## **Town of Durham**

## <u>Planning Consultant's Review</u> Planning Board Meeting – Wednesday, January 22, 2020

- XI. **Public Hearing** Mill Plaza Redevelopment. 7 Mill Road. 1) Site plan review and 2) Conditional Use for mixed use and activity within the wetland and shoreland overlay districts. Colonial Durham Associates, LP, property owner. Sean McCauley, agent. Joe Persechino, Tighe & Bond, engineer. Steve Cecil and Emily Innes, Harriman, site planner. Ari Pollack, attorney. Rick Taintor, Town's Contract Planner. Central Business District. Map 5, Lot 1-1.
- I recommend that the Board reopen the public hearing and vote to continue it to a date certain in February 2020.

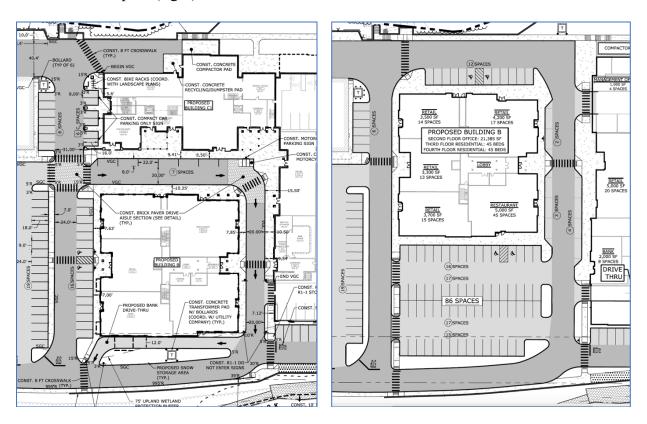
3) In terms of physical layout (as opposed to residential density), the key changes to the Mill Plaza Redevelopment project are in the middle of the site, centered on proposed building "B". The following images show this area in the 9/14/2018 plan (left) and the 10/22/2019 plan (right).

Some changes from the 2018 site plan to the new plan include the following:

- The 2018 plan included two buildings (designated as C1 and C2) that were joined into what would look like a single L-shaped building wrapping around the third proposed building (designated as B). In the new plan, building C1 has been eliminated and building B has been shifted northward.

- The 2018 plan proposed a continuous street and pedestrian route through the site, extending from the front of the Hannaford building across the front of building C1, and then wrapping around building B. In the new plan, that street and pedestrian route are eliminated as a result of removing building C1 and shifting building B to the north. The pedestrian route through the site is now proposed to be accommodated by providing a wide corridor bisecting building B.

- The reconfiguration of the proposed buildings results in a reduction in overall building coverage and an increase in the total area of parking spaces. Compared to the 2018 plan, the new plan increases the total number of on-site parking spaces from 363 to 424 (+61, or 17%), and the number of on-site surface spaces from 263 to 340 (+77, or 29%). This increase in the proposed on-site parking supply is accompanied by a reduction in potential parking demand due to a 22% decrease in the number of proposed beds (from 330 to 258).

- In order to compensate (in part) for the reduction in building footprints, building B is now proposed to be four stories tall rather than three stories.
